Product Change Notification

Product Change Notification: PCN-26-277325

DEUTSCH DT3P Integrated resistor connectors Laser marking removal

Current drawing (plug example)

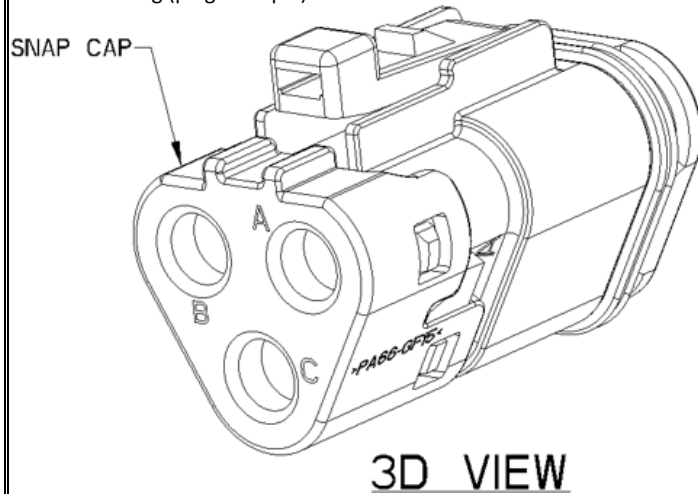
The Industrial and Commercial Transportation business unit of TE Connectivity is making a change to remove the laser marking from the cap of our integrated resistor connectors for the part numbers listed below. These PNs are TE proprietary designs, therefore considered catalog/general market product. PPAP and/or sample requests must be submitted within 14 days of PCN submission via ict-ppap-request@te.com or ePPAP system. Submission will not occur without request. If PPAP requested, disposition response is required within 14 days of submit date or it will be considered approved. Product drawings are affected.

Future drawing (plug example)

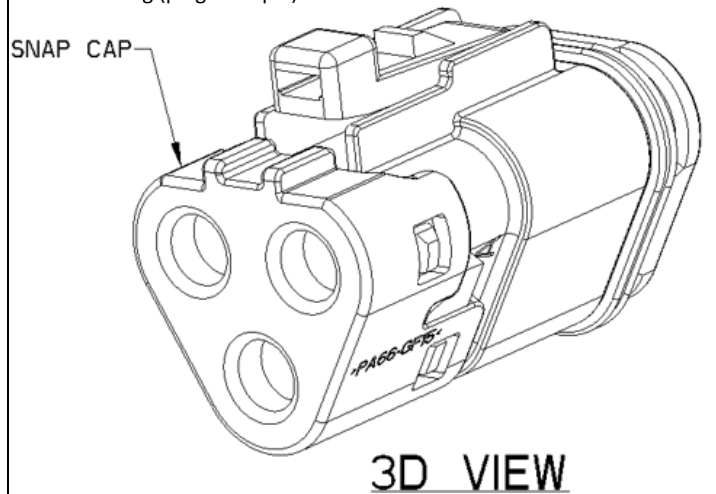
Dear Customer, we are informing you of a standardization change to our DT integrated resistor product line. The laser marking on the connector cap will be removed. This is a cosmetic change only; the grommet design includes intentionally closed cavities. There is no impact to form, fit, function, or performance. Current and previous revisions are interchangeable. The change will be phased in, and mixed shipments may occur.
